PLAN AND ZONING COMMISSION MEETING

CITY OF DAVENPORT, IOWA

TUESDAY, APRIL 5, 2022; 5:00 PM

Case P22-02: Request of Klingner & Associates, P.C. on behalf of Rob Fick LLC for a Preliminary Plat of Oak Brook 2021 for a 30 lot subdivision on 12.4 acres located east of Sturdevant Street and north of 61st Street. [Ward 8]

PRELIMINARY
PLAT

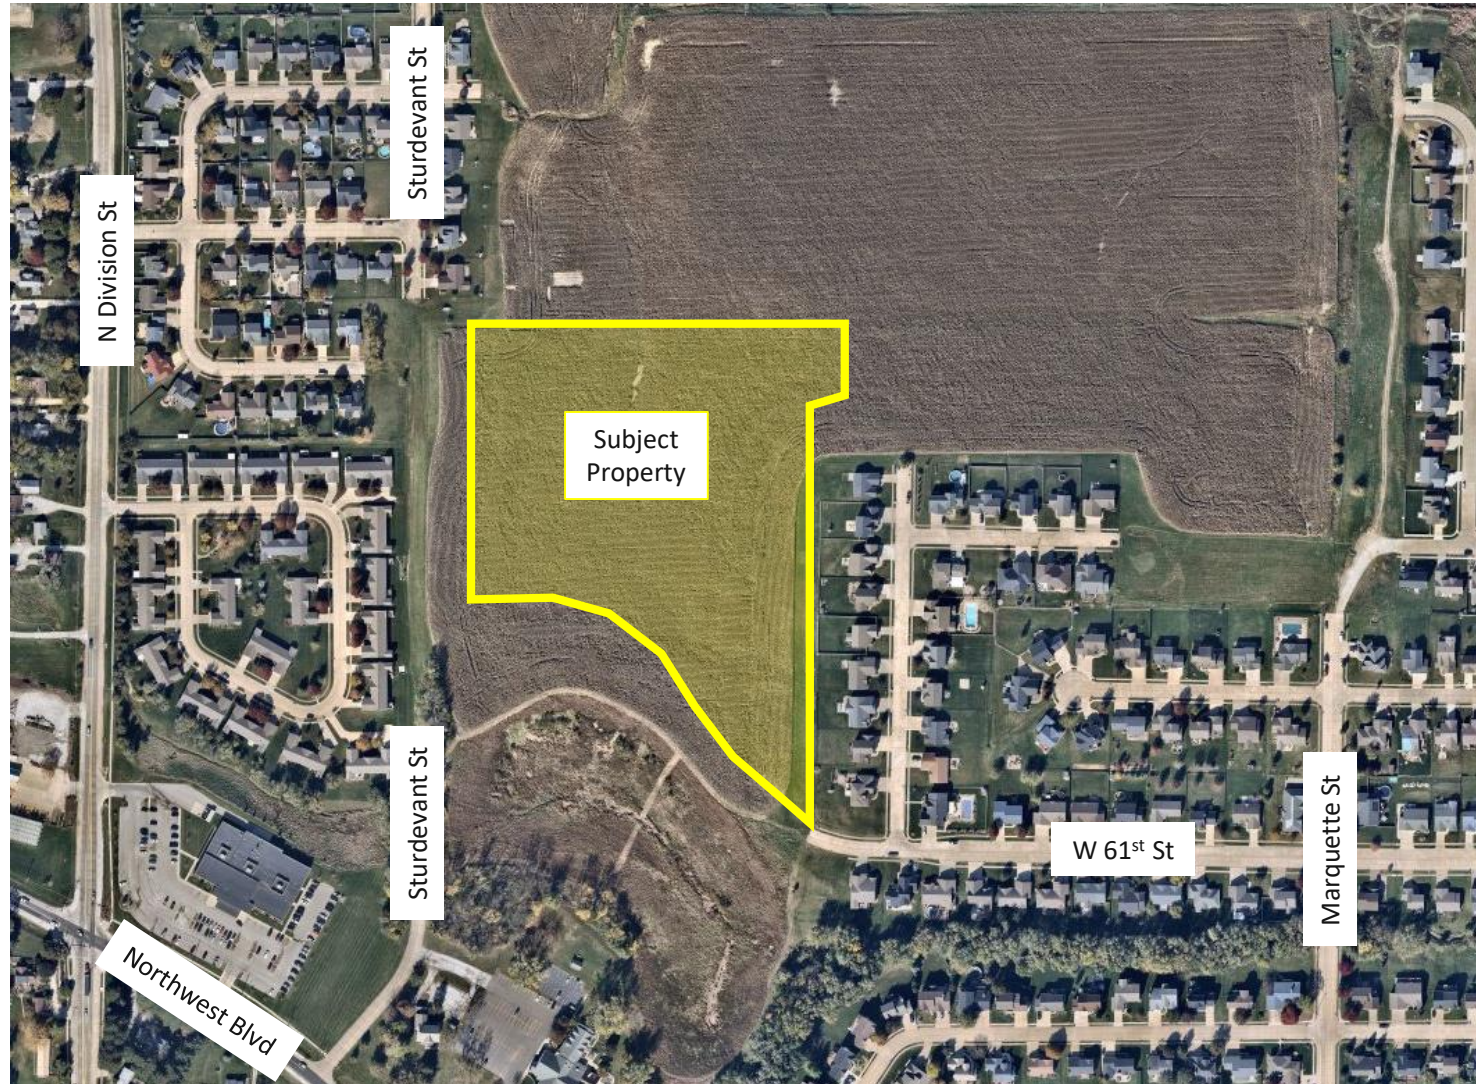
1. Add a note stating, "Sidewalks shall be constructed along all street frontages prior to the completion of residential construction for each lot, or as so ordered by the City of Davenport. "
2. Indicate the width of existing pavement at the 61st Street connection point.
3. The size of the existing sanitary sewer where connection is being made shall be labelled.
4. Provide the proposed width(s) of pavement.
5. Label building setback lines.
6. The final plat shall require an easement with a hammerhead turnaround at the terminus of West 64th Street.
7. Add a note stating, "Storm water quality treatment and storm water detention is required for this subdivision. A provision for storm water detention for this subdivision has been made in the regional detention facility located immediately south of West 61st Street. This facility is owned and maintained by the City of Davenport."

- Streets: The subdivision will have access via the extension of 61st Street. Two new north-south streets will be dedicated and connected through a new east-west street, labelled as 54th Street. At a future date, Sturdevant Street will be extended to connect the two existing roadway stubs. However, this extension requires additional right-of-way from the property owner to the west. All streets as shown meet Davenport Municipal Code requirements.

- Storm Water: The R-3 District permits a maximum impervious surface of 60% for each lot. The development of the property will need to comply with the City's storm water requirements. Storm water quality treatment and storm water detention is required for this subdivision. A provision for storm water detention for this subdivision has been made in the regional detention facility located immediately south of West 61st Street. This facility is owned and maintained by the City of Davenport.

- Sanitary Sewer: Sanitary sewers will be extended from existing infrastructure to serve this subdivision. Additional storm and sanitary sewer easements shall be required based on preliminary engineering of conceptual plans.
